# Product/Process Change Notice (PCN)

PCN #: ConUSB\_20130724  
 Product Affected: 61400416021  
 Effective Date: 31.08.2013

<u>Old Design</u>	<u>New Design</u>

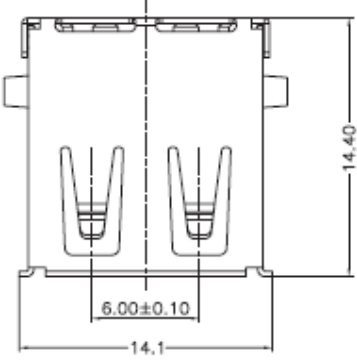
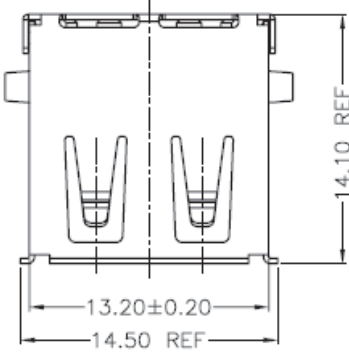
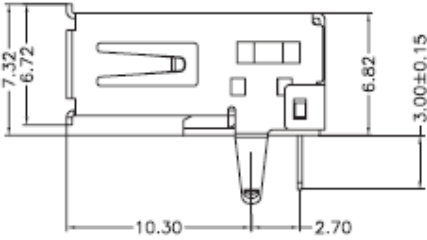
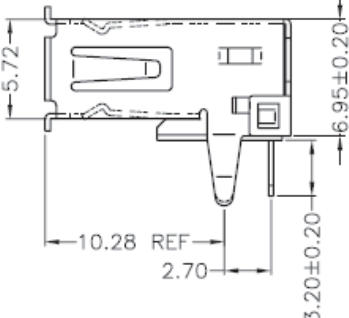
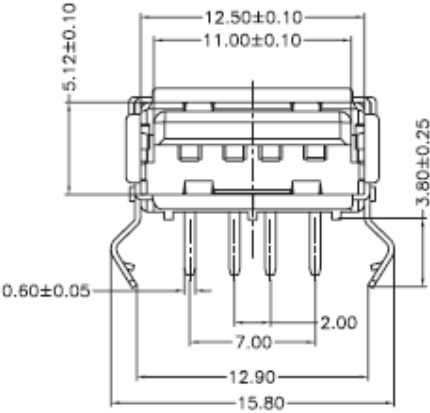
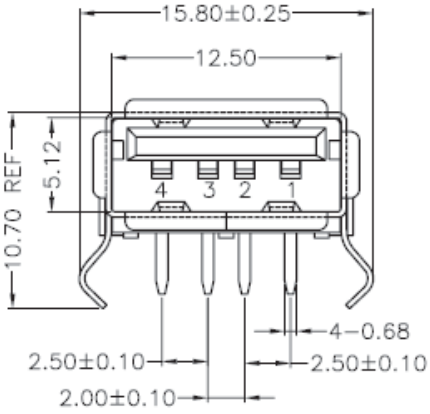
The tooling of the production is broken due to circumstances beyond our control. A new tooling has been developed by Würth Elektronik eiSos. Therefore the new tooling will be henceforth installed. The immediate change affects external dimension due to the improved design of the new tooling. The enclosed drawings show detailed the changes. Nevertheless, all function and performance will remain the same.
